Mount Thorley Warkworth

2016 Annual Environmental Review - Addendum

In response to request for additional information by DPE

June 2017

Figure 1: MTW Overview

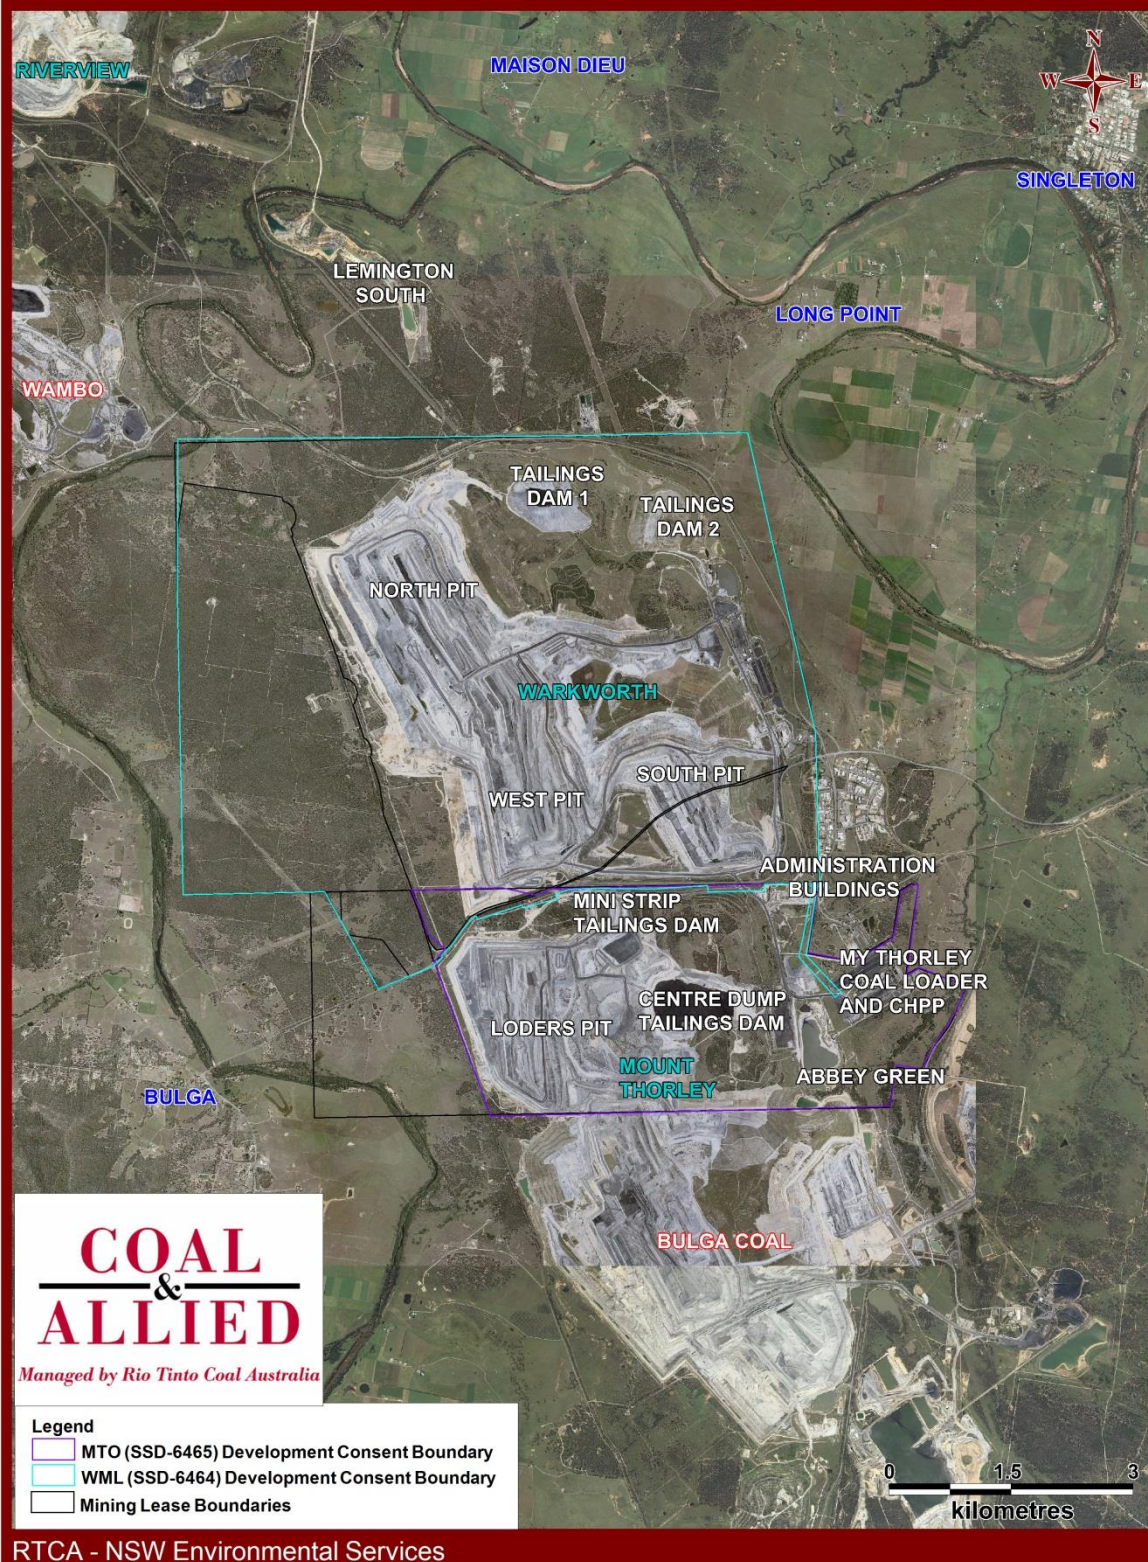
Figure 1 in section 2.2 of the Annual Review includes a map showing the development consent boundaries for the project but doesn't include all the detail required in Section 2 of Annual Review Guidelines – Post-approval requirements for State significant mining developments, Department of Planning and Environment (DPE, 2015) Please amend the map to include:

- *Regional context*
- *Mining lease boundaries*
- *Current operational disturbance footprint; and*
- *Offset areas.*

Figure 1 shows the development consent boundaries, mining tenement boundaries, the offsets for MTW, as well as where MTW sits relative to its near neighbours and neighbouring mine sites. Figure 2 shows the broader regional geographic context of MTW and the Offset Areas. Figure 3 shows the current operational disturbance footprint included as Appendix 4 in the submitted 2016 MTW Annual Review.

Figure 4: Implementation Timeline

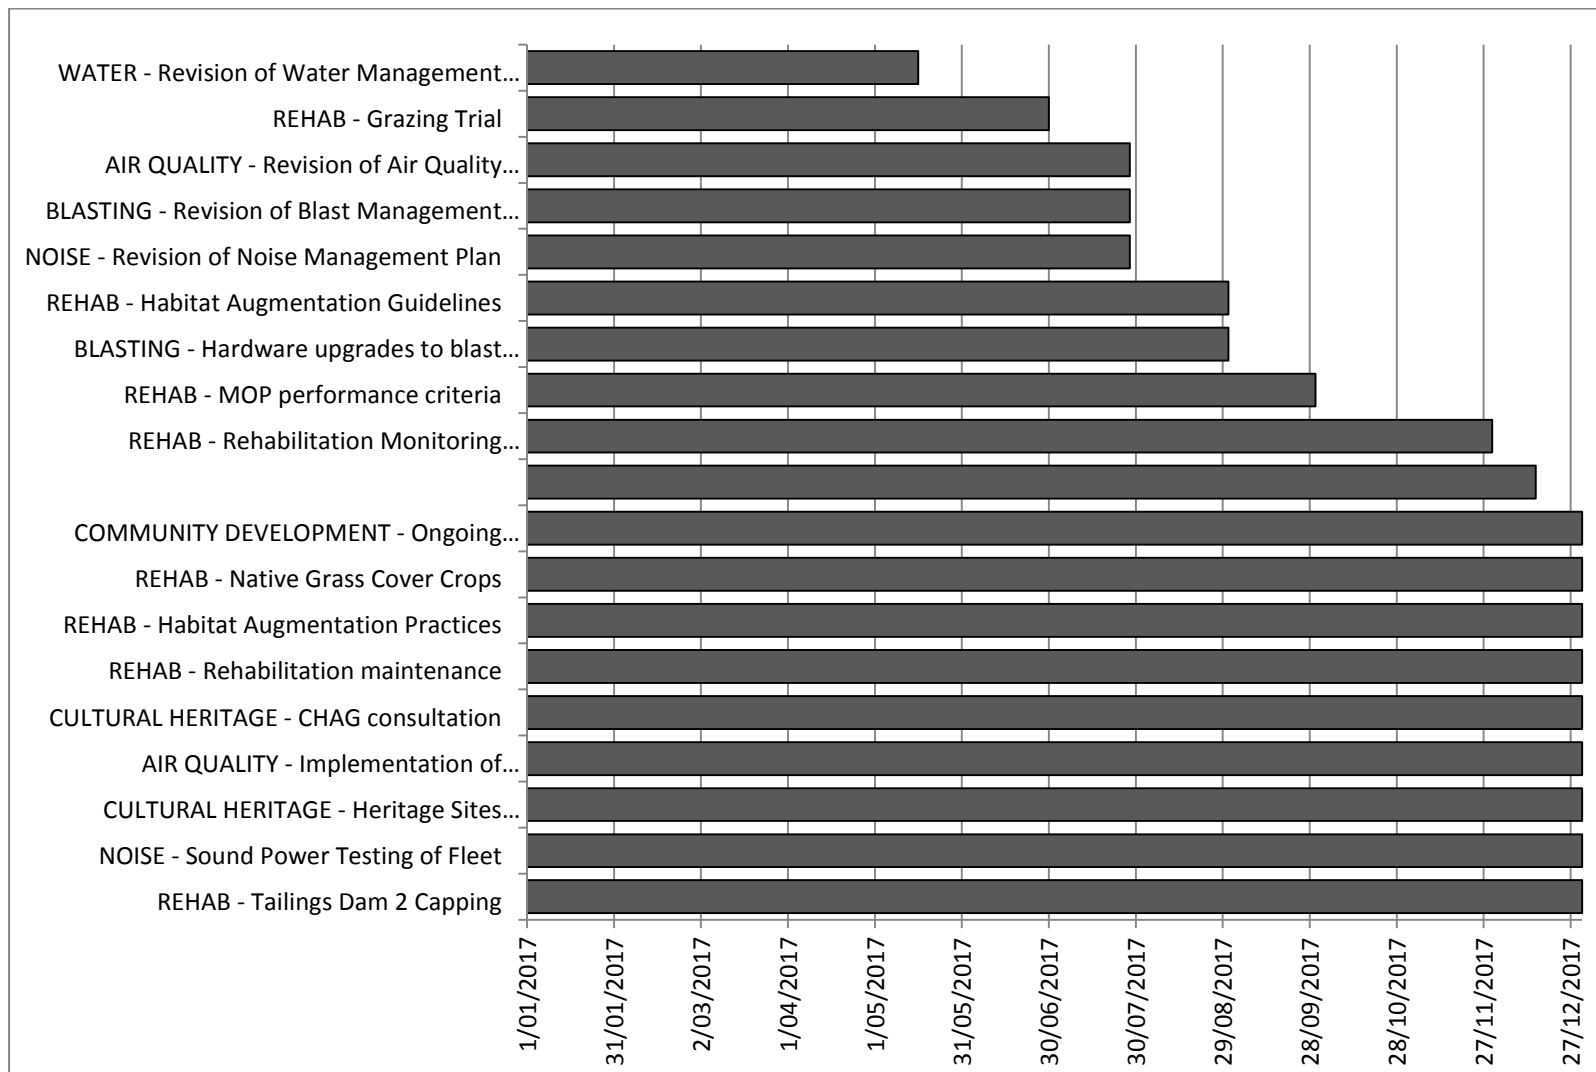
Section 12 of the annual Review describes what environmental and community performance improvements will be completed next reporting period but does not include a timeline for implementation. Please amend section 12 to include an implementation timeline.

An implementation timeline has been prepared to illustrate completion schedule of activities outlined in section 12, see Figure 4 below. Activities which are scheduled to occur for the entirety of the year or are scheduled to be completed in the following year have been given an end date of 31st December 2017 for illustration purposes.
